ADDENDUM #5 – MARCH 4, 2024

RE: NORTH BAY FIRE STATION
Seismic Upgrade and Addition
Project #21.59

- **REVISED Sheet S2.2 Structural – Roof Framing Plan**
- **REVISED Sheet S7.2 Structural – Wood Framing Detail**

ROOF FRAMING PLAN
SCALE: 3/16" = 1'-0"

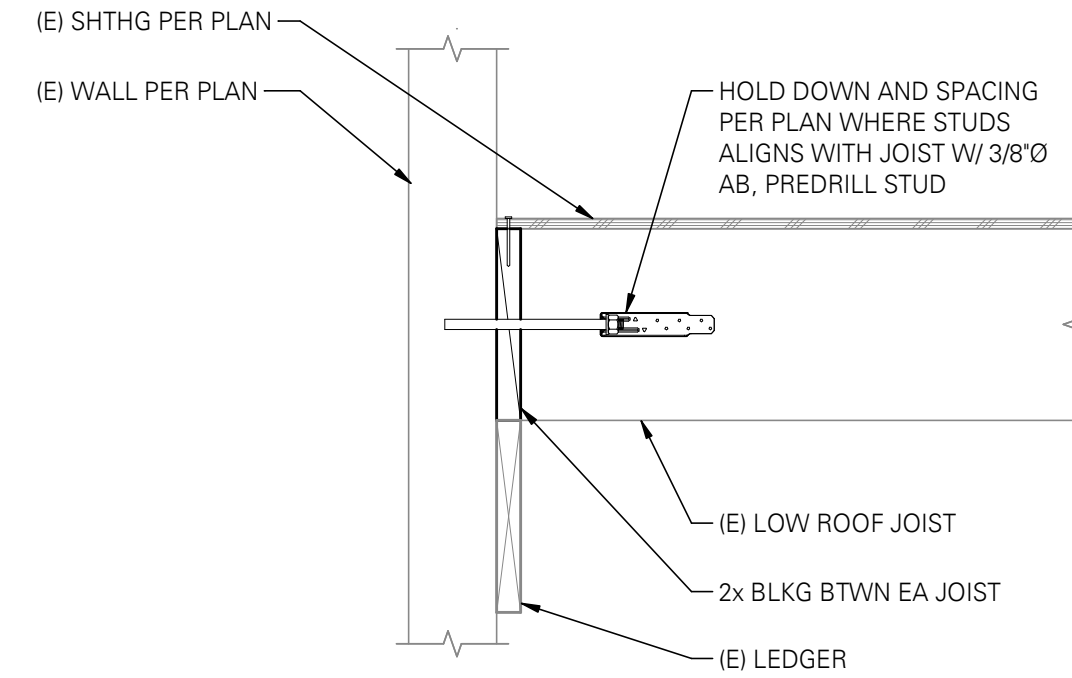
1. **Sheet S2.2, Footing at Grid 1:** Make the following notes:
 - a. A cold joint is acceptable for a 2-pour installation. Contractor to submit a joint location for review prior to construction.
 - b. See attached structural sheets S2.2 and S7.2 with added information for top of wall to roof connection.
